Sonoma County Planning Commission Minutes

Item No. 2 **Time:** 1:05 p.m. **File:** PLP03-0094
Applicant: North Bay Construction **Staff:** Blake Hillegas
Env. Doc.: Environmental Impact Report
Proposal: The applicant proposes: 1) a Zone Change to add the MR (Mineral Resource) combining district to 198.76 acre site designated LEA (Land Extensive Agriculture) B6 - 160 acre density Z (Second Unit Exclusion), VOH (Valley Oak Habitat); 2) A Use Permit to develop a 70-acre quarry (Roblar Road Quarry); 3) A Reclamation Plan to reclaim the site upon completion of mining to open space use, including a conservation easement and an irrevocable offer of dedication for public use; and 4) Cancellation of the Williamson Act agricultural preserve contract on APN 027-080-009 while simultaneously placing a Williamson Act agricultural preservation easement on a 243-acre agricultural property near Petaluma. The annual aggregate production quantities are proposed to be a maximum of 570,000 cubic yards per year for 20 years.

The responses to the comments of each individual commenter are contained below. For ease of reference, each response corresponds to the numeric designators identified in the Plann

Figure PC-1
Existing Parcels and Residences - 1 Mile Radius of Proposed Mining Area

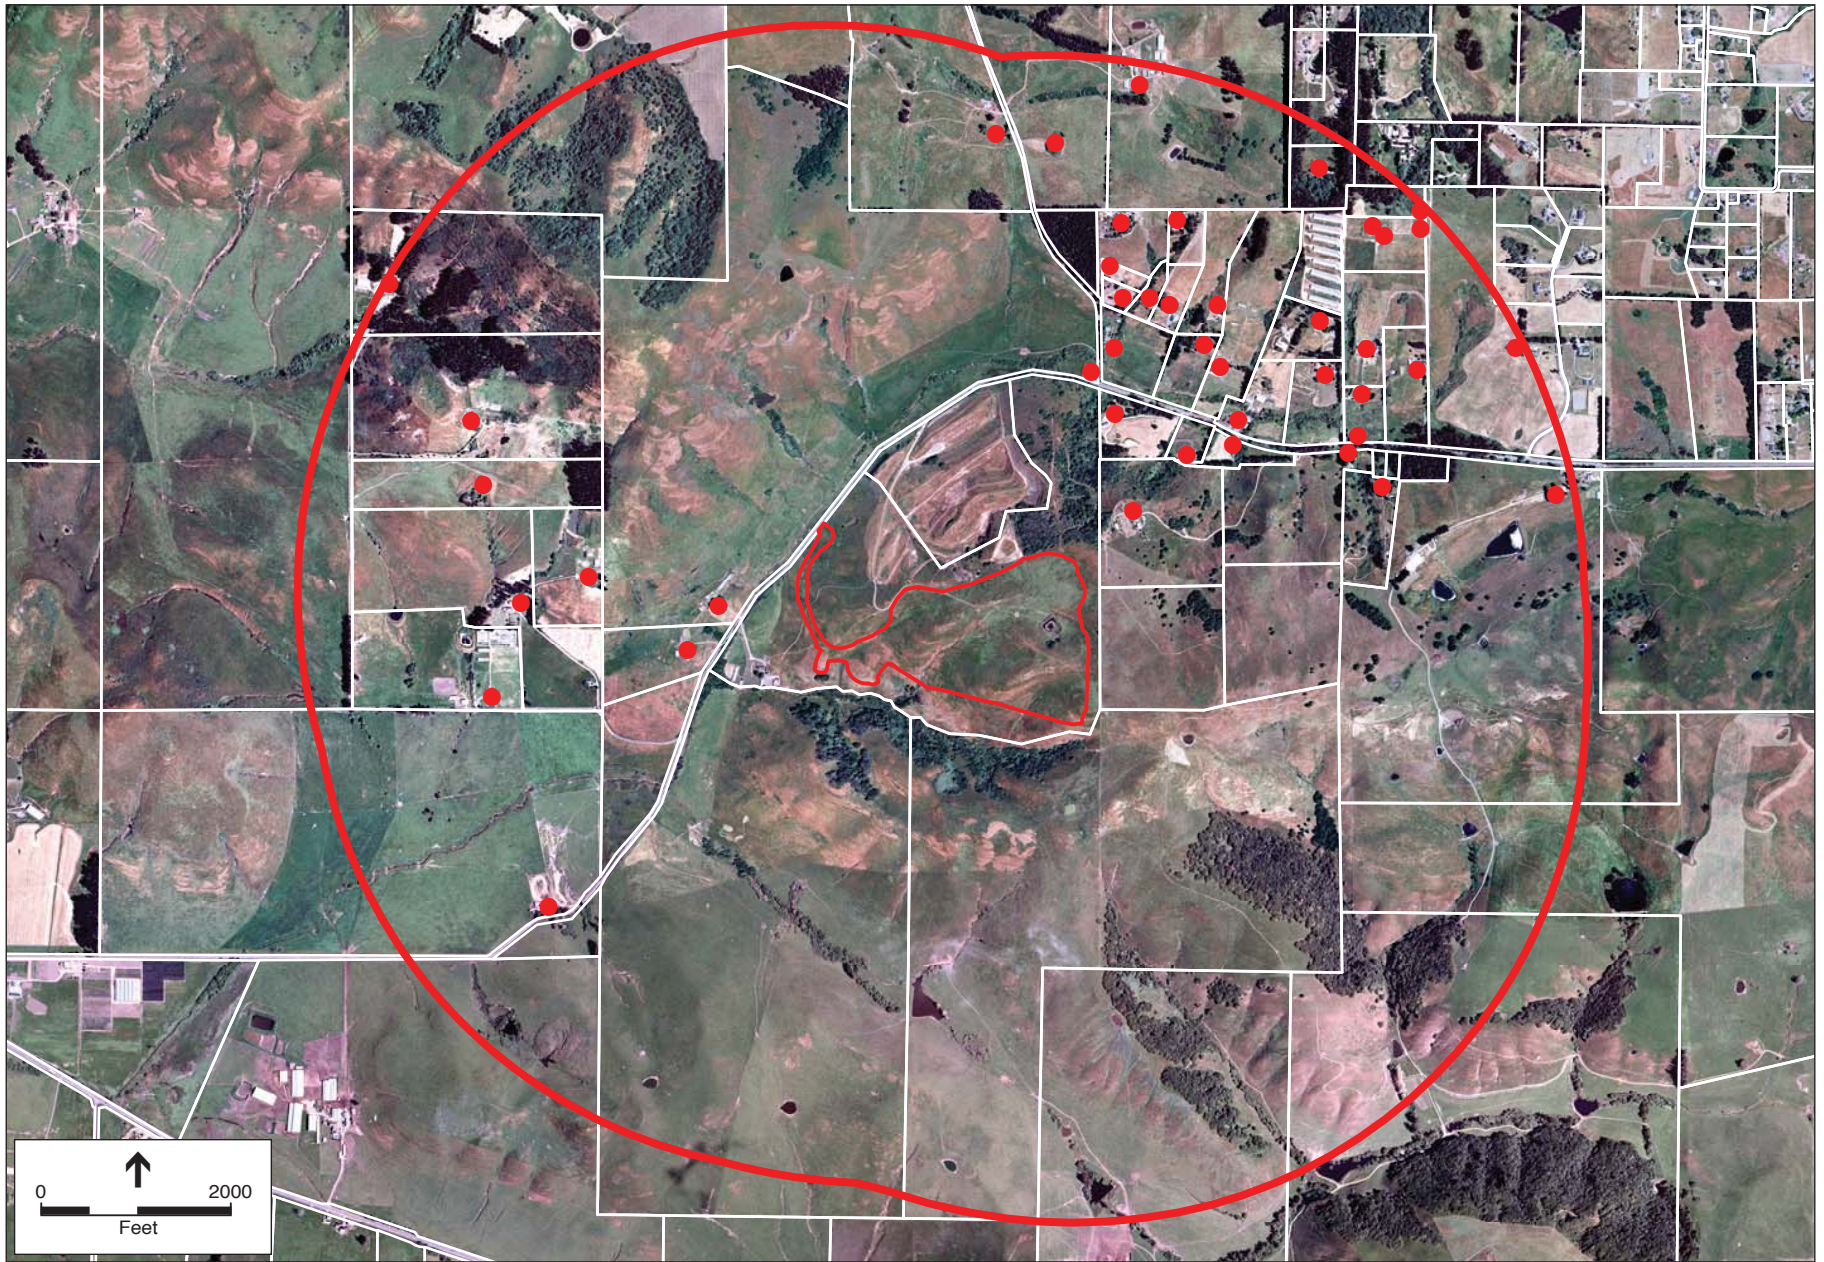
PC-96 The Commissioner requests that the number of residences be shown in an exhibit that shows the ¼, 1/3, and one-mile radius. Existing residences located within proximity to the proposed mining area have been identified through the use of aerial photography and field observation (see Figure PC-1 on the following page). Approximately 43 single family residences are located within a mile radius of the proposed mining area. The majority of these residences are situated to the northeast and over a hill from the proposed mining area (see attached aerial photo). Ten of these residences are situated across Roblar Road to the west.
